RYLANDS BUILDING MANCHESTER

PROPOSED DESIGN AMENDMENTS

October 2024

The purpose of this document is to provide supporting information to the amendment applications for Rylands Building, Manchester.

SECTION 03

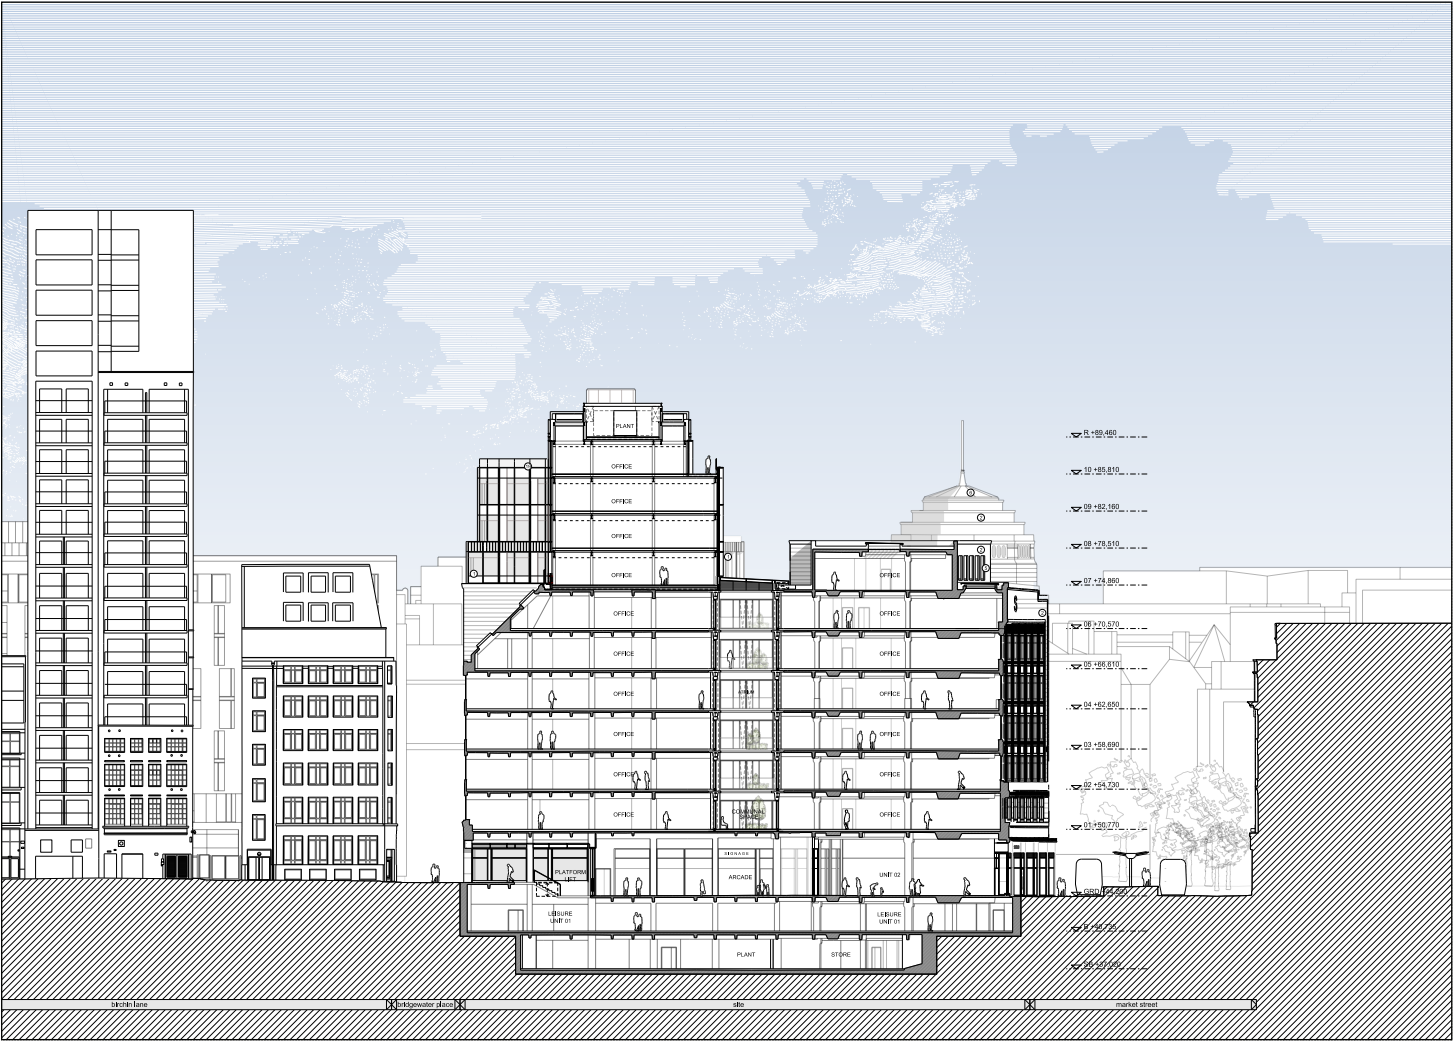
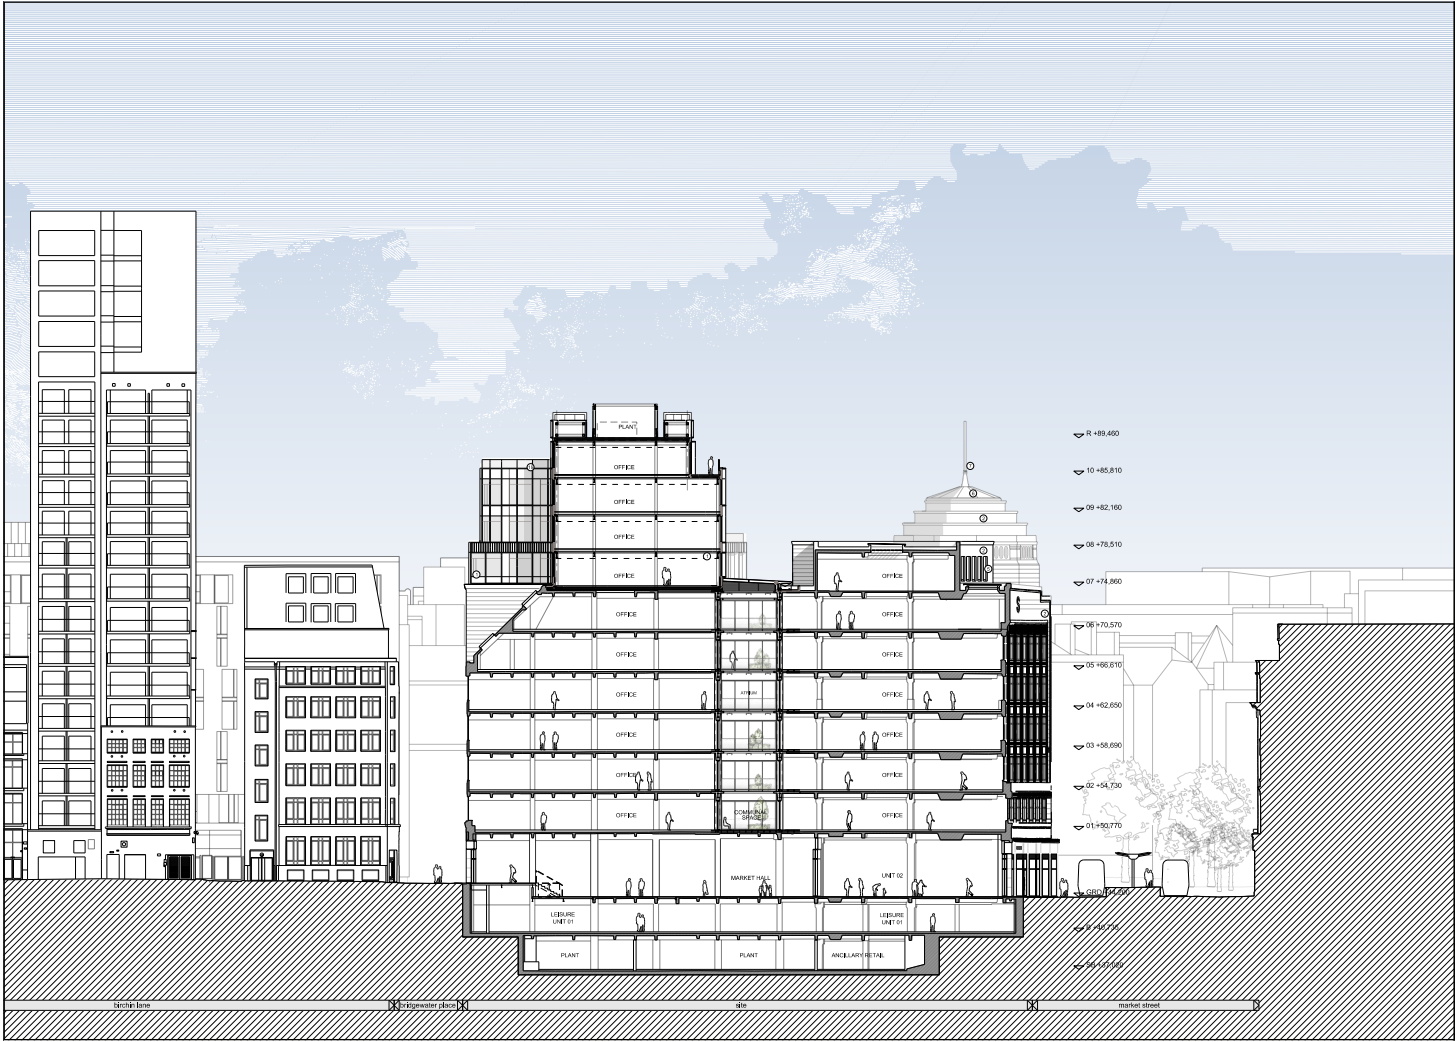
LEVEL 07 PLANT SPACE

SAWTOOTH ROOF DETAILING

LEVEL 11 PLANT SPACE

CORE 02 AMENDMENT

ELEVATION A - SOUTH

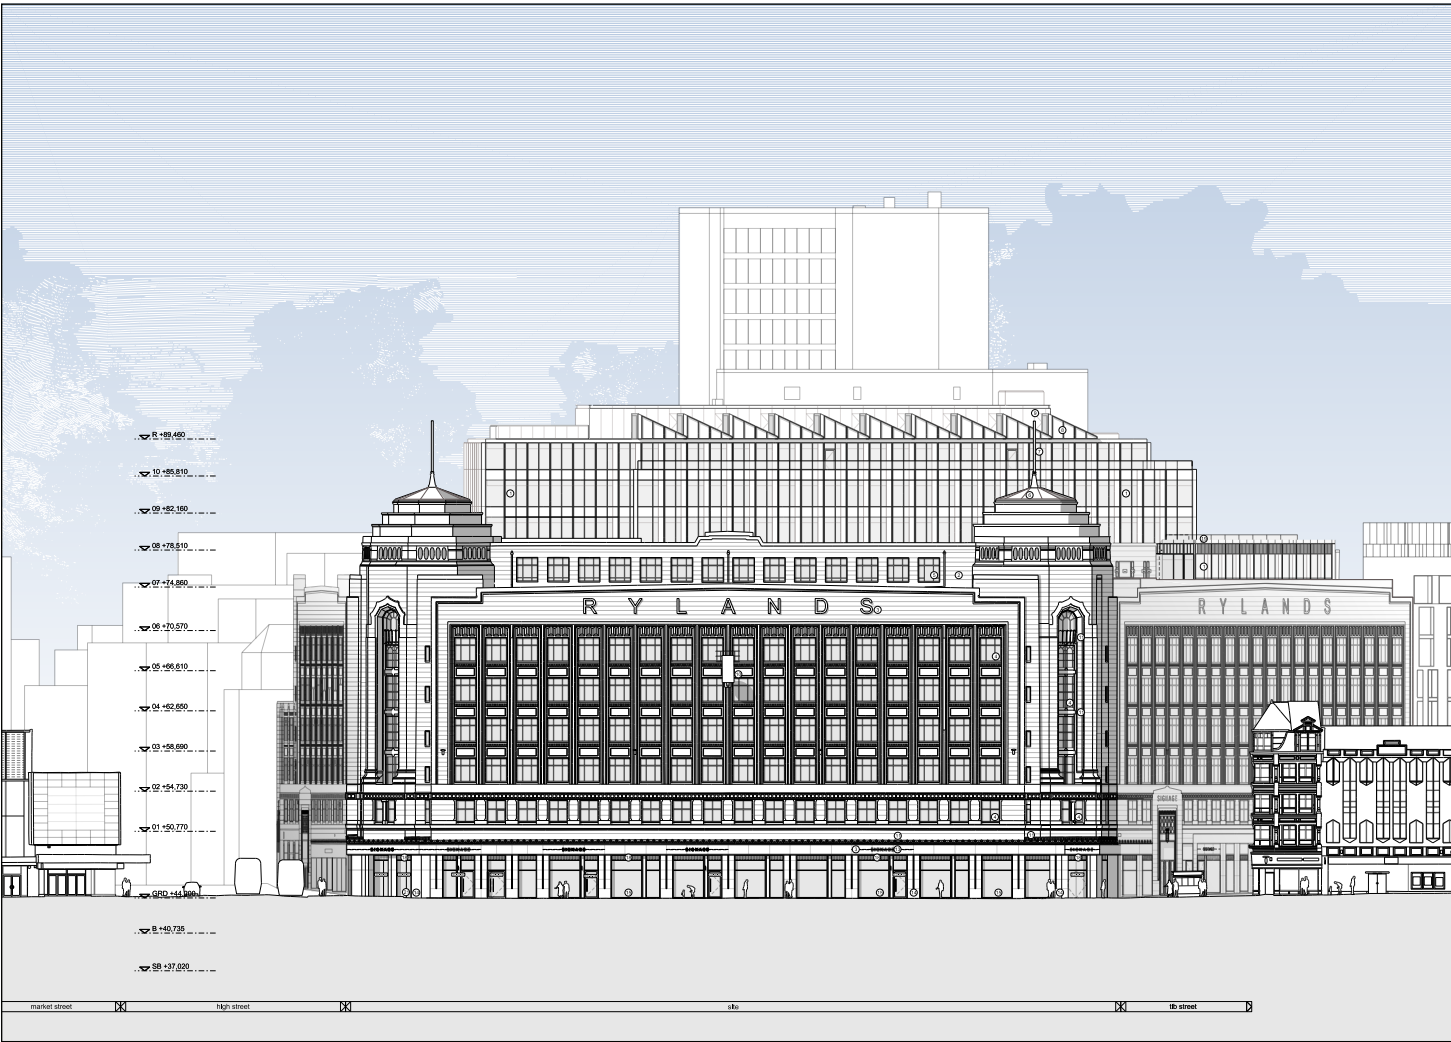
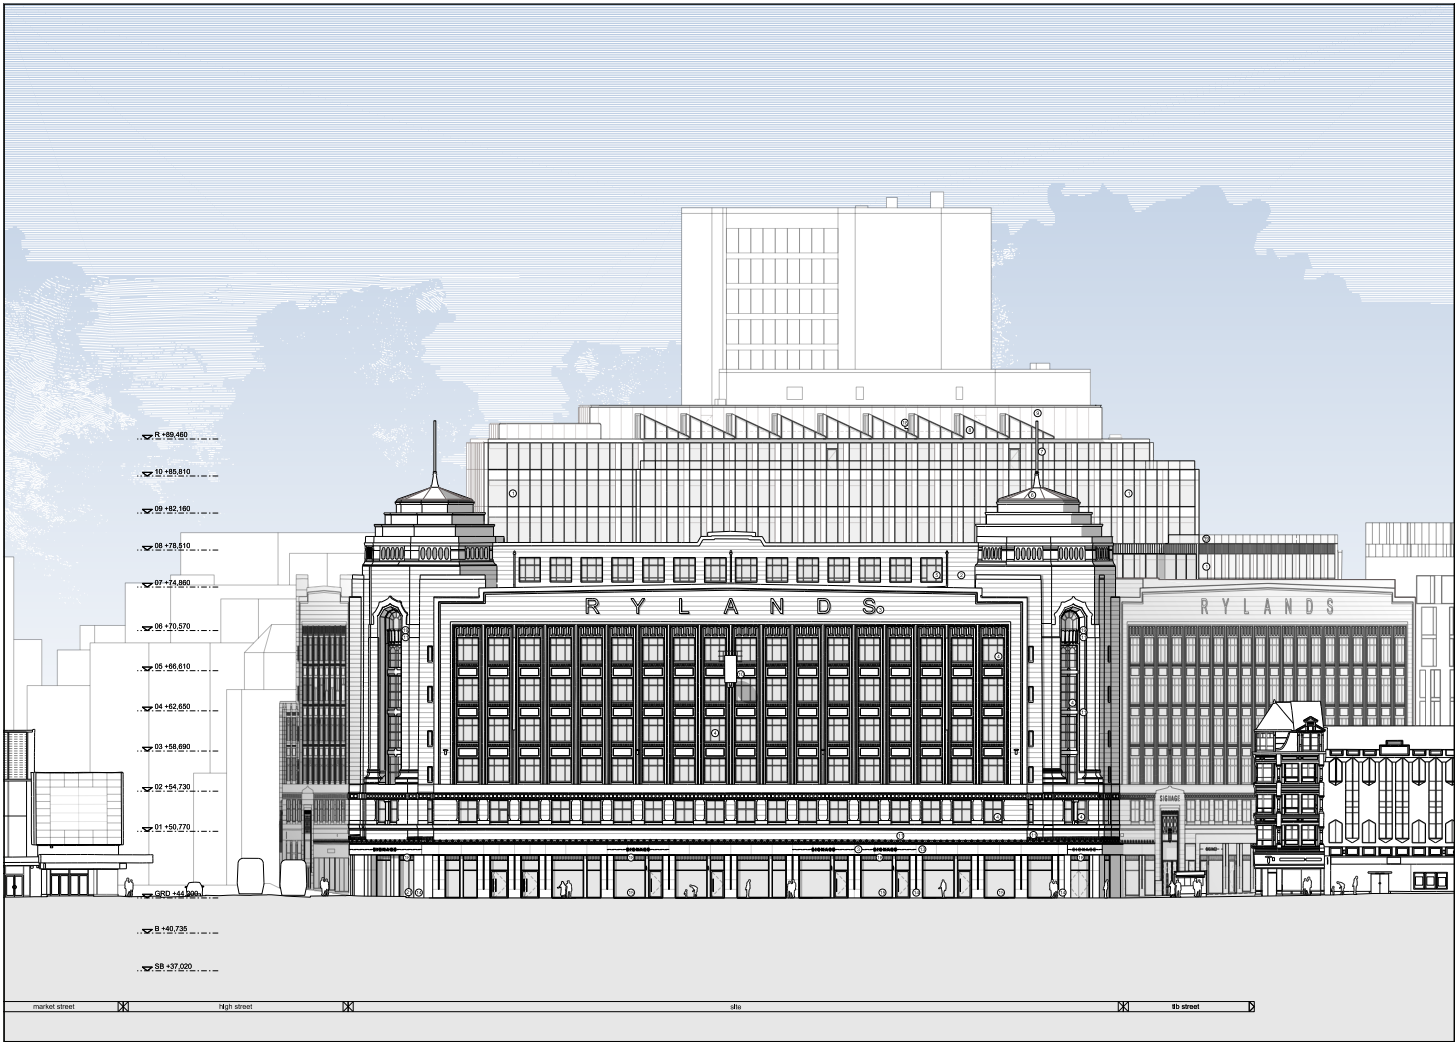
- LEVEL 07 PLANT SPACE
- LEVEL 11 PLANT SPACE
- UCW CLADDING AMENDMENT
- SAWTOOTH ROOF DETAILING
- GROUND FLOOR SHOP UNITS

ELEVATION B - EAST

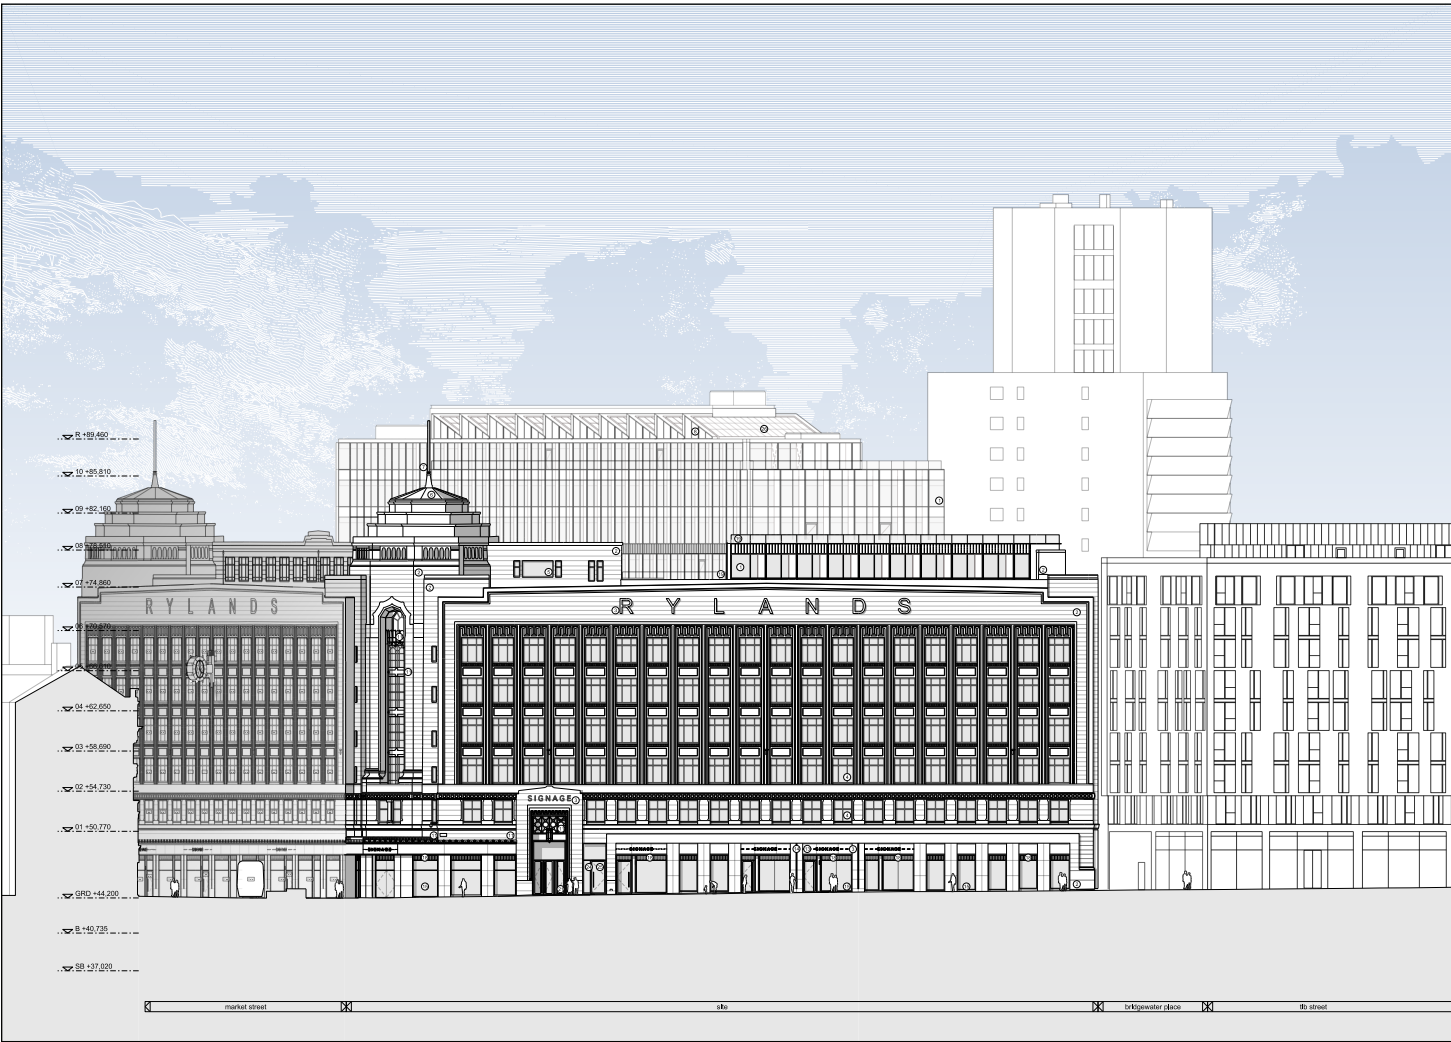
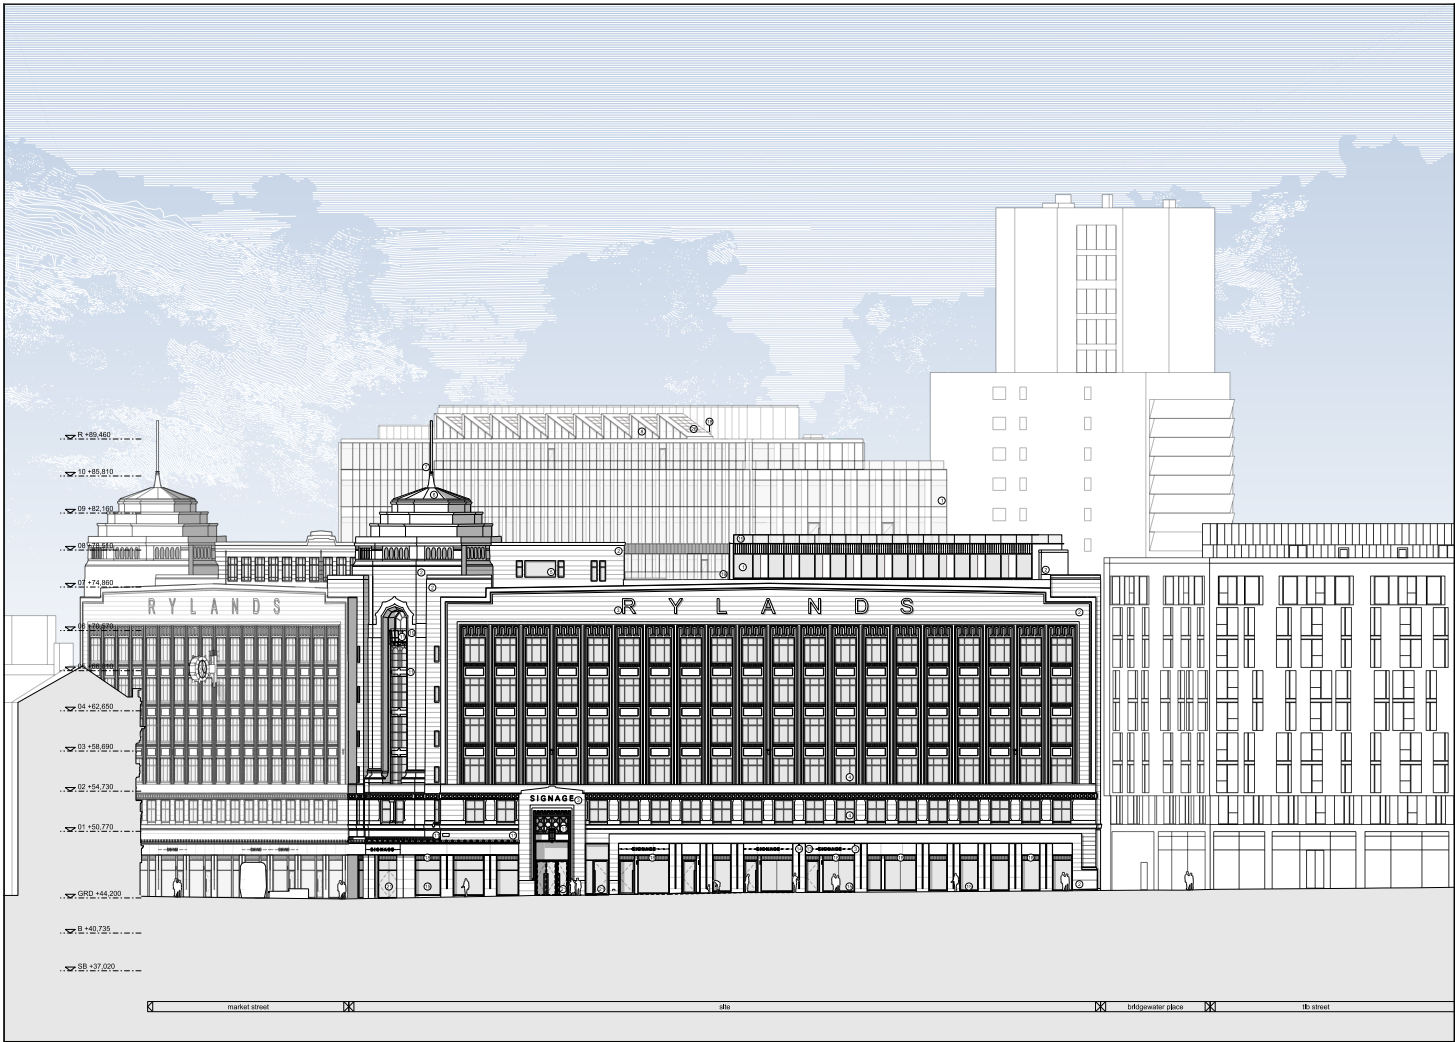
- LEVEL 07 PLANT SPACE
- LEVEL 11 PLANT SPACE
- UCW CLADDING AMENDMENT
- SAWTOOTH ROOF DETAILING
- GROUND FLOOR SHOP UNITS
